Serial No. 92-115
NL&P/JBL: R4
Docket No. 50-338
License No. NPF-4

VIRGINIA ELECTRIC AND POWER COMPANY
NORTH ANNA POWER STATION UNIT 1
RESPONSE TO NRC COMMENTS ON THE
STEAM GENERATOR INSPECTION AND STARTUP ASSESSMENT

North Anna Burst Test Matrix

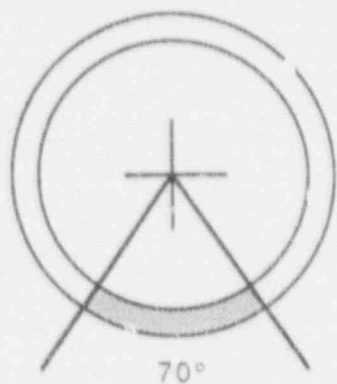
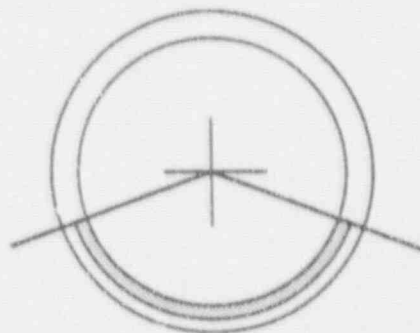
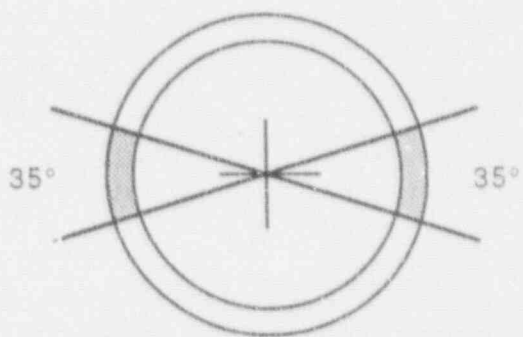
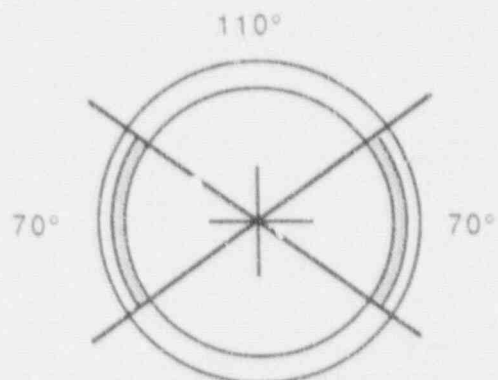
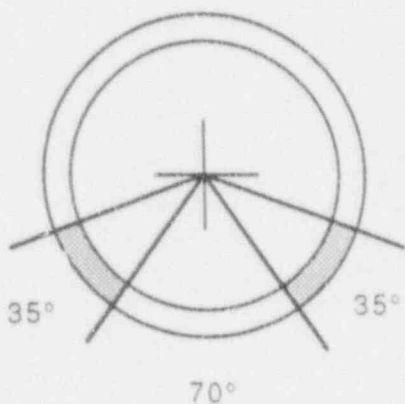
The Westinghouse response to NRC Question No. 3 (in Westinghouse Report SG-91-12-014) does not resolve the staff concern regarding multiple crack indications (MCIs). Specifically, the staff continues to believe that a rationale needs to be developed to demonstrate that projected EOC multiple cracks will not excessively degrade tube integrity. In the meantime, to support operation through the next planned cycle, MCIs found during the current inspection should be evaluated to ensure that the affected tubes retain adequate integrity per Reg. Guide 1.121. Thus, even if we don't have a projected number and size distribution of MCIs, these should be a basis for concluding that MCIs of the next EOC will be within acceptable limits.

In order to address NRC staff concerns, Virginia Power has authorized Westinghouse to perform a series of tube burst tests to better ascertain the implication of MCI geometries on tube integrity. A total of five (5) different crack geometries are planned for testing using tubes containing simulated MCIs. The specimens will be fabricated from proto-typic tubing using Electric Discharge Machined (EDM) notches to simulate circumferential cracks. A schematic of the planned burst test configurations is attached. A summary report of the test results will be provided to the NRC for review subsequent to the completion of the tests. However, due to the short duration of the remaining cycle of operation (i.e., approximately 9 months), we do not consider the test results to be an issue for North Anna Unit 1 operation through January 1993.
